Riverine Scour and Lateral Migration Assessment at Select Sites for a 36" Natural Gas Pipeline

Prepared for:

Terracon

Flood Control District of Maricopa County Approved Methodology
December 6, 2007 Meeting Attendance
Flood Control District of Maricopa County Comments, Dated January 11, 2008
Response to Flood Control District of Maricopa County Comments

Figure 7 - Area 2 Location

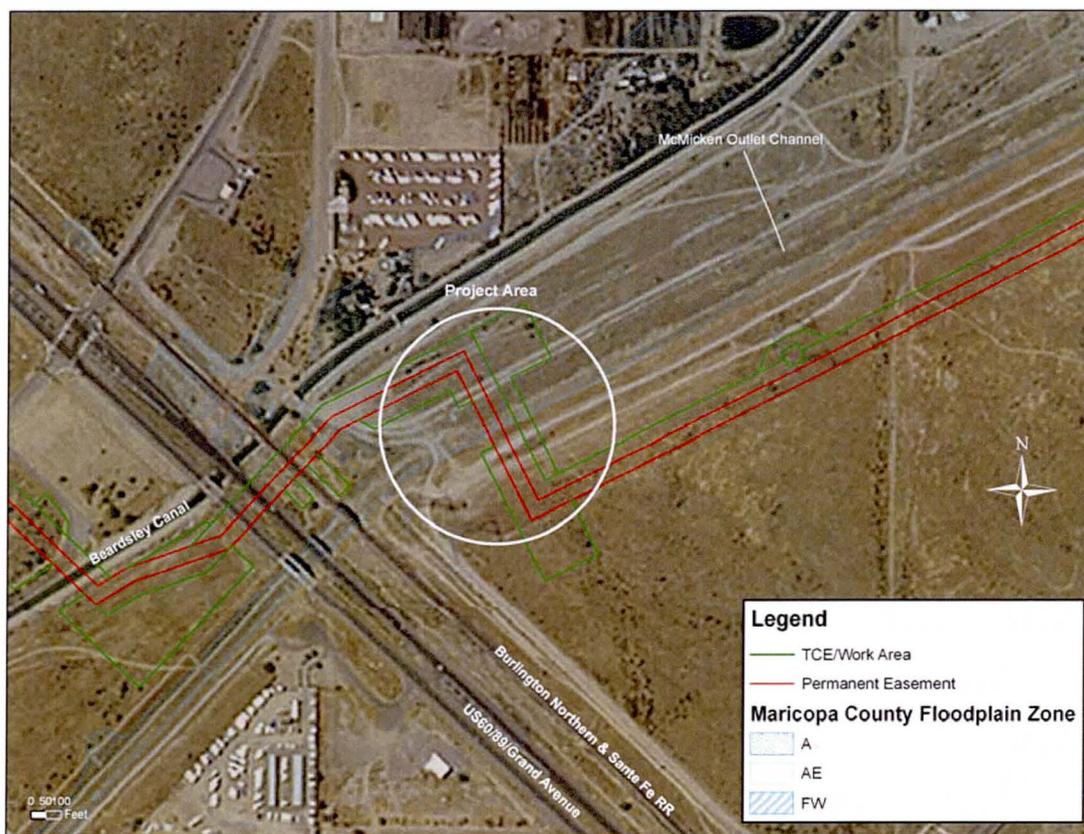
- 12) On page 14 of the report, it is indicated that Figure 7 shows the lateral migration extents and the scour depths; however, these are not shown in the figure. Please show the depths and extents on the figure.

12) *On page 14 of the report, it is indicated that Figure 7 shows the lateral migration extents and the scour depths; however, these are not shown in the figure. Please show the depths and extents on the figure.*

- **The wrong figure was referenced. The reference has been changed to Figure 9 which shows the extents for multiple areas including Area 2. The extents for Area 3 have been removed from the figure for clarity.**

Figure 9 - Area 2 Scour Extents

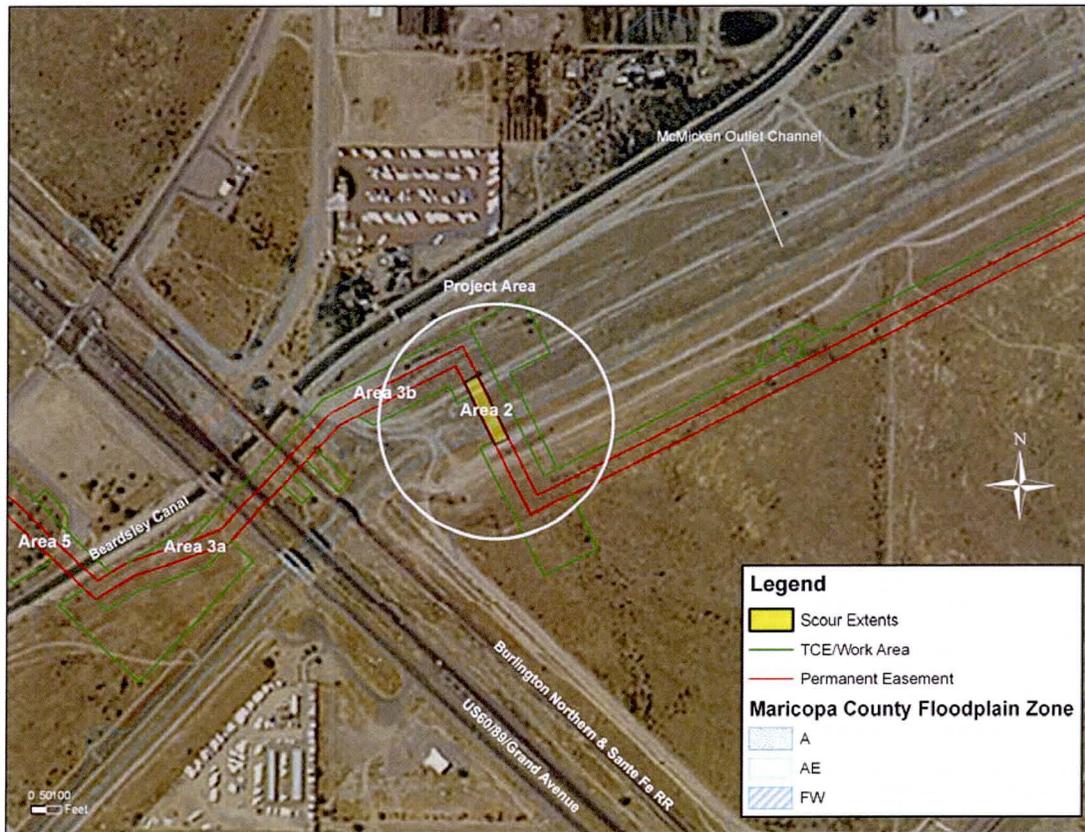
- 13) The scour extents, shown on Figure 9 on page 15 of the report, appear to be incorrect. They show the scour extents for areas 2, 3a, 3b, 4 and 5. Please correct the scour extents on Figure 9.

13) *The scour extents, shown on Figure 9 on page 15 of the report, appear to be incorrect. They show the scour extents for areas 2, 3a, 3b, 4 and 5. Please correct the scour extents on Figure 9.*

- **See the response to the previous comment.**

Figure 16 - Area 6 Location

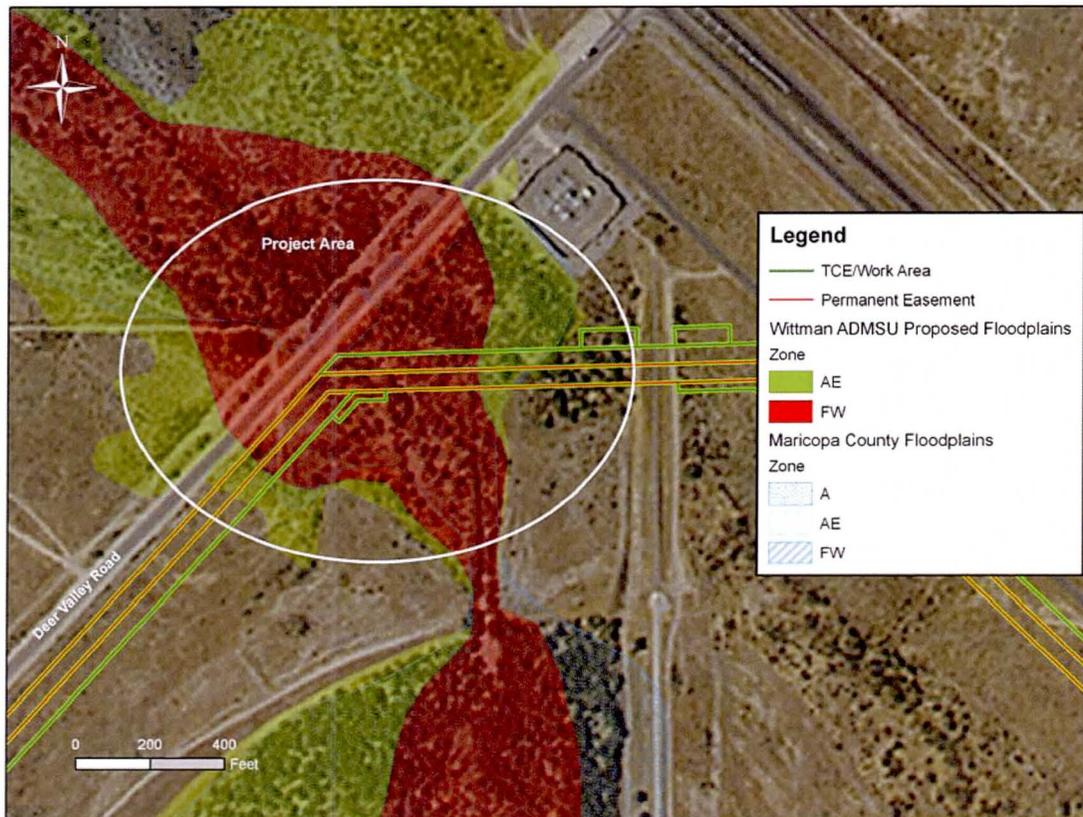
- 14) The scour extents, shown on Figure 12 on page 19 of the report, appear to be incorrect. They show the scour extents for areas 2, 3a, 3b, 4 and 5. Please correct the scour extents on Figure 9.

14) *The scour extents, shown on Figure 12 on page 19 of the report, appear to be incorrect. They show the scour extents for areas 2, 3a, 3b, 4 and 5. Please correct the scour extents on Figure 9.*

- **See the responses to the previous two comments. Figure 12 has been removed.**
